Title: Committee Site Plan

Reference: 0764/15

Site: Land on the west side of Broad Road, Bacton

Project: Broad Road, Bacton (Planning Ref: MS/0764/15) **Job No:** IT1527
Subject: Off Site Highway Improvements: Additional Information
Prepared by: Chris Glegg **Date:** 14/08/2015
Checked by: Justin Bass **Date:** 17/08/2015

IT Project		BROAD ROAD, BACTON	
Rev:	B	Sign Amendment	4.8.15
Rev:	A	Revised section below & extended OS Map	30.1.15
Rev:		Description	Date
Drawing No:	IT 1527/SK/03	GAO File:	IT1527_SK_01.dwg
Date:	JUL 2015	Scale:	1:500 (unless stated)
Client:	MRS C ABBOTT	Drawn by:	EC
		Approved by:	SW

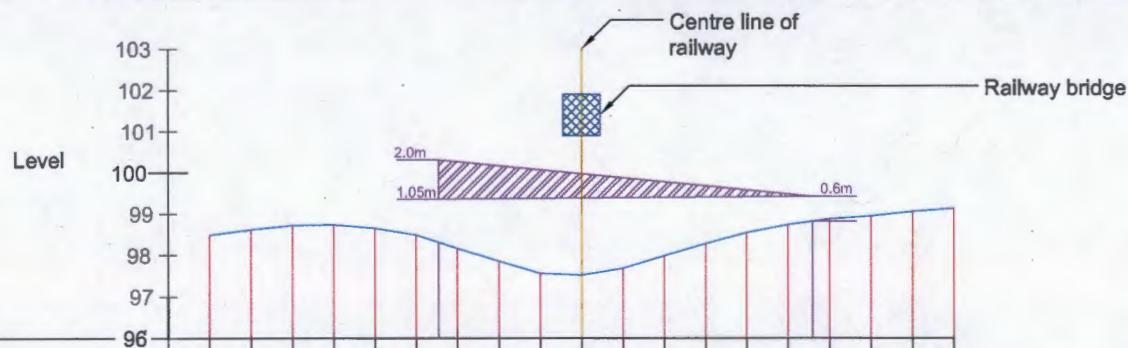
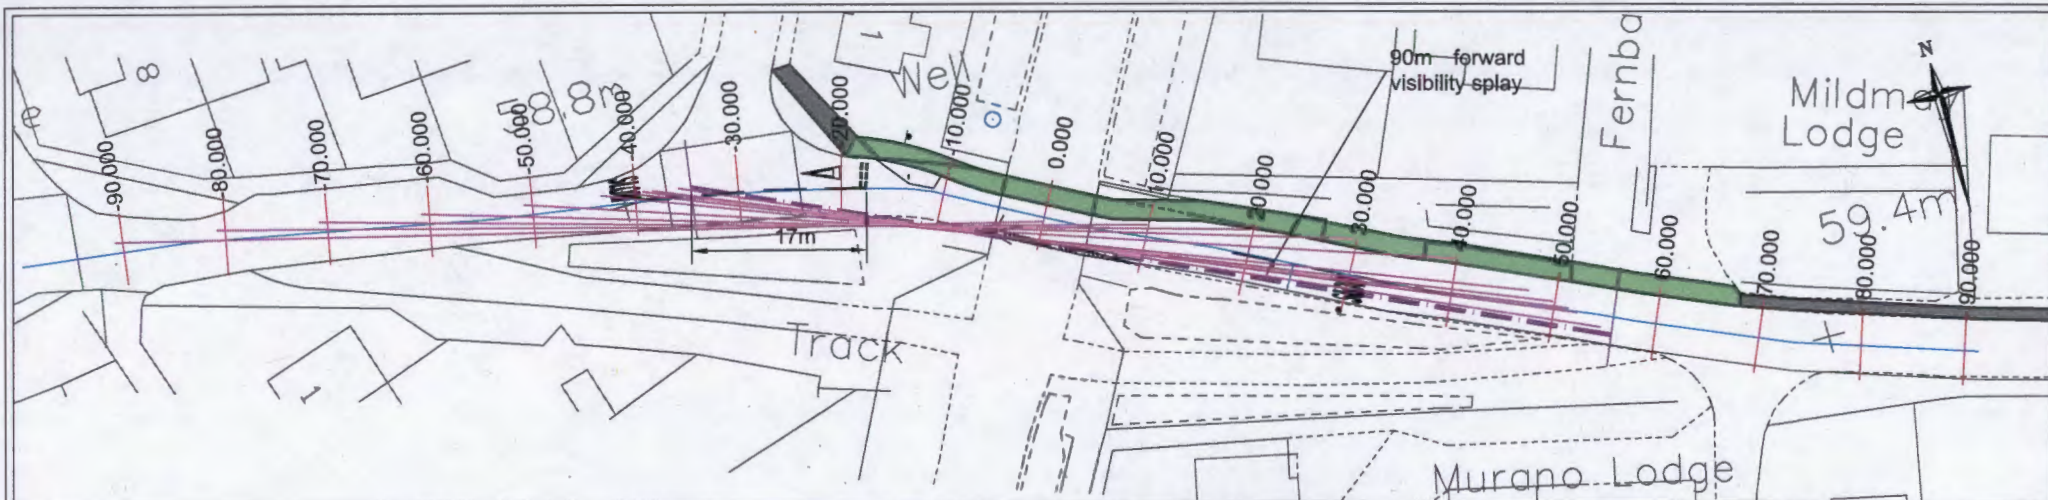
In addition to the footway connection to the village centre, as shown on the applicant's drawing no. IT1527/SK03 Rev B, the site layout must incorporate a footway along the site frontage. This will improve highway safety as the new footway will highlight to drivers that there is a change in character of the road and this is likely to result in a reduction in vehicles speeds. In addition, our Street Lighting Team have indicated that street lighting will be required from the new estate to the junction with Pound Hill which will reinforce the change in nature of Broad Road and assist in reducing speeds.

1.
No dwelling shall be occupied until the proposed footway connection to the village centre and associated priority system as shown on drawing no. IT1527/SK/03 Rev.B having been revised as required by the Highway Authority has been provided in accordance with details which previously shall have been submitted to and approved in writing by the Local Planning Authority.

(Annotated Drawing showing the location of Problems
Highlighted in This Stage 1 Road Safety Audit)

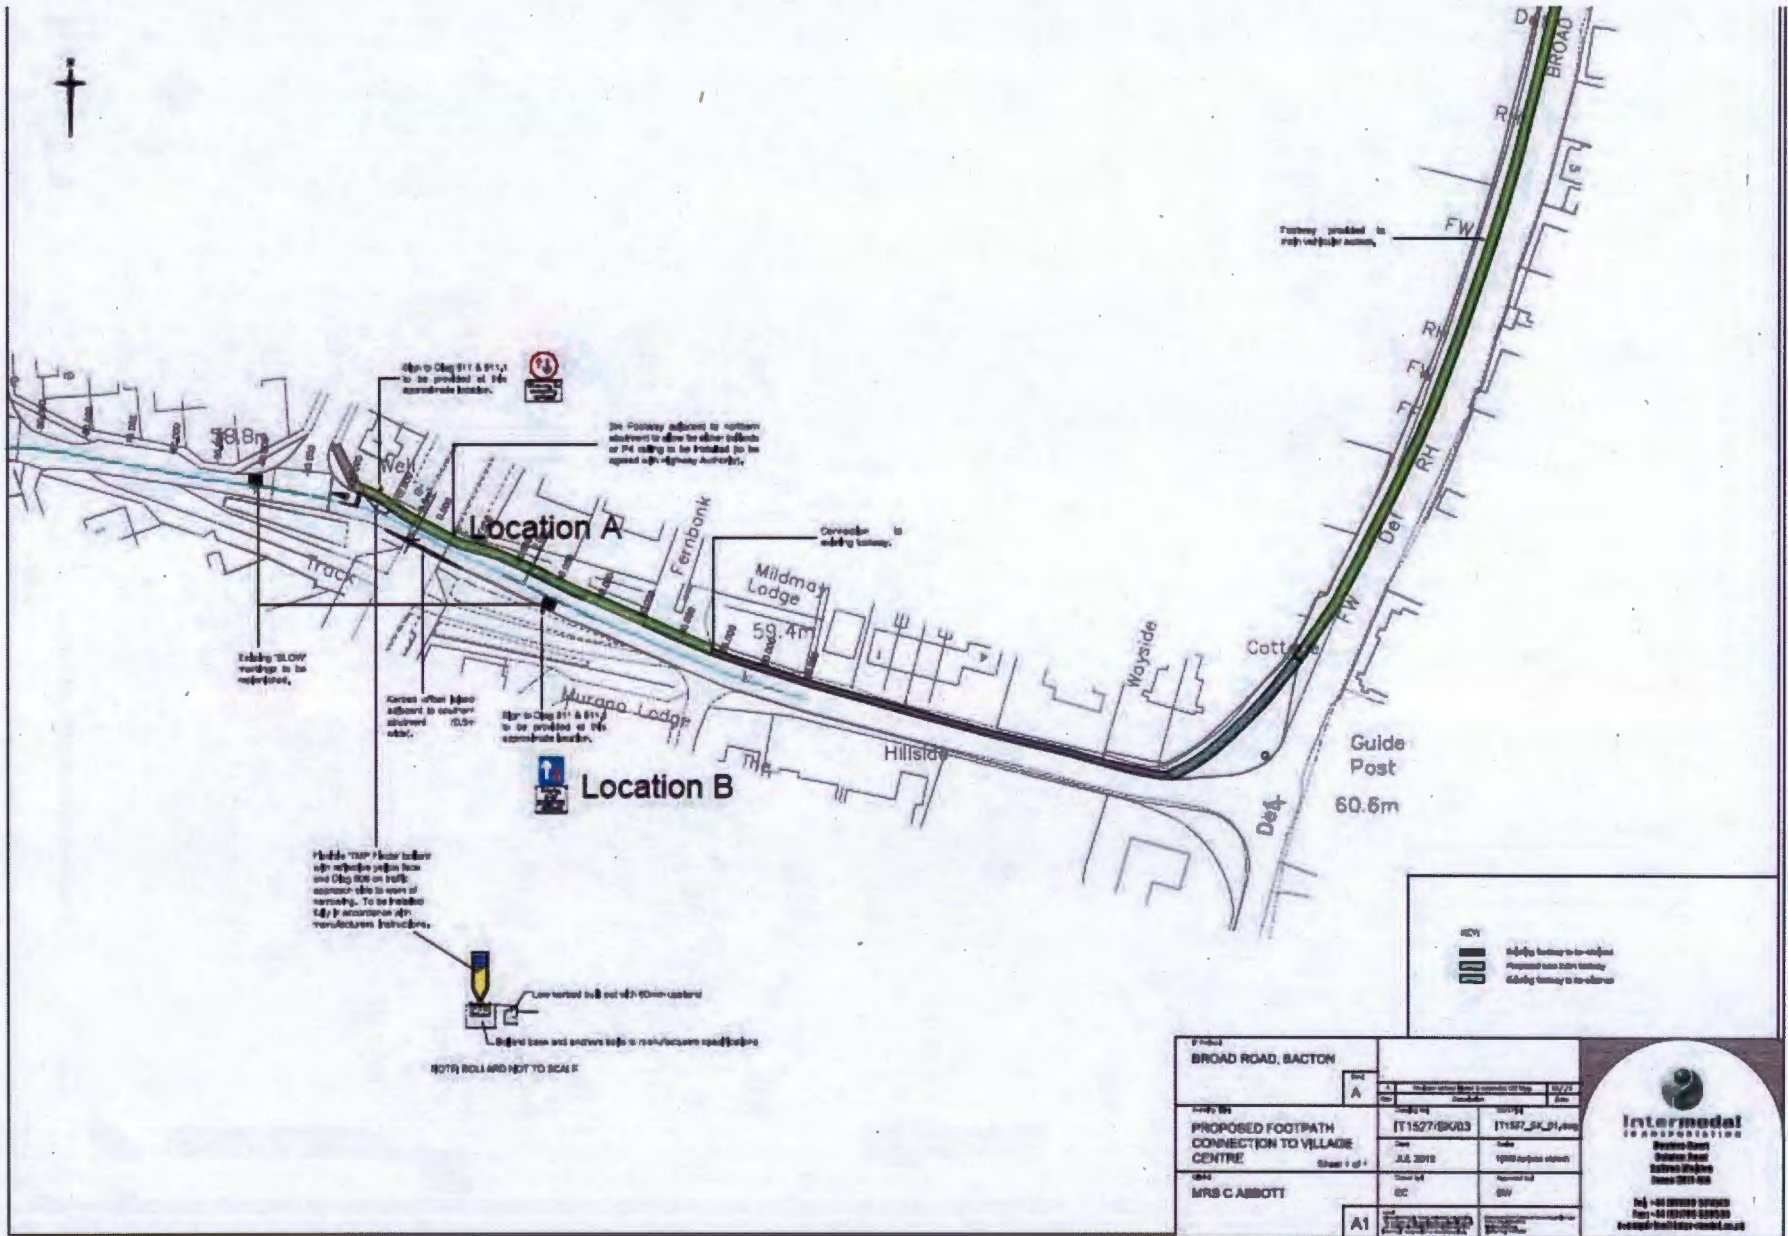
The drawing provided shows the provision of either bollards or P4 railings on the 2m wide footway adjacent to the northern bridge abutment. It is not clear if these are to be set at the rear of the footway or kerbside. In either case if provided kerbside they must be 450mm from the edge of the kerb thereby reducing the available width for pedestrians and mobility scooter users to 1.55m. Studies find that pedestrians and other footway users tend to move away from walls, railings and bollards which will reduce the available width, this in collaboration within the 1.55m available space will not provide sufficient footway space.

The Audit Team note that the location of the existing westbound 'SLOW' road marking shown on the drawing is too far to the west and is in fact adjacent to the maintenance track opposite property named 'Mildmay Lodge'. This may impact upon the design location of the 'Priority working' road sign as it could cause an obstruction to maintenance vehicles (See photo below).

2.3	Y	The position of the 'SLOW' marking and the priority one way working sign is a matter that can be further refined at detailed design stage to ensure that there are no conflicts with the maintenance entrance to Network Rail's land. The position of the sign shown on the drawing appears to avoid such conflict in any event.
